Docket Item #20
DEVELOPMENT SPECIAL USE PERMIT #2003-0005
EPISCOPAL HIGH SCHOOL SCIENCE BUILDING

Planning Commission Meeting
November 6, 2003

ISSUE: Consideration of a request for a development special use permit, with site plan, for construction of a science classroom building and to increase enrollment.

Roof Top Mechanical Section

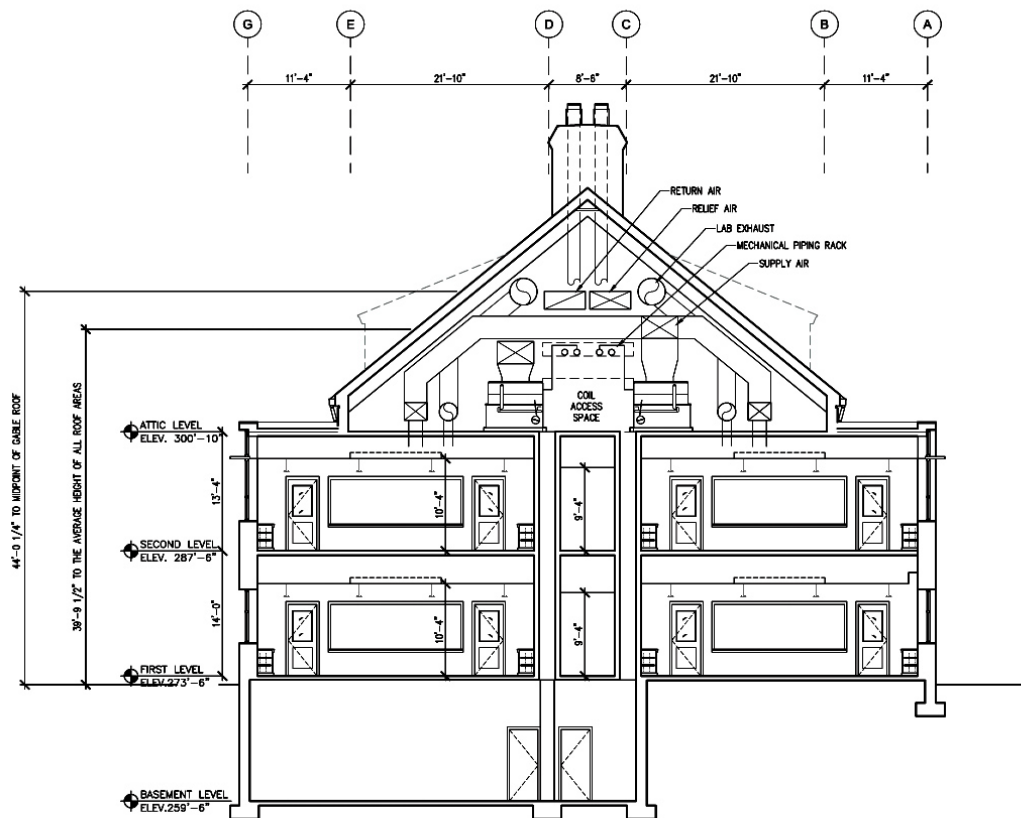
With reference to the proposed building height of 44 feet, the gable roof structure is actually four (4) feet taller than permitted by the R-20 zone building height restriction of 40 feet. The mechanical system requirements for the science building require specialized mechanical equipment for air handling circulation and ventilation because of the science laboratories. Under Section 6-403 (B)

of the zoning ordinance, roof top mechanical appurtenances may be erected as part of the main building to their required heights, regardless of any other height provisions or restrictions of the ordinance, provided that it meets criteria as set forth in Section 6-403 (B) through (E). The proposed roof structure falls under the provision of section 6-403 (B)(1). The roof is designed to the minimum height necessary to house the extensive air handling and mechanical systems contained within the roof structure. The structure could have been designed with a flat roof in compliance with the 40' height limit. However, that would have required the mechanical equipment to be housed in an obtrusive penthouse structure measuring at least 13 feet in height atop a flat roof. The building design would not have been compatible with the historic character of other existing buildings located in this quadrant of the campus.
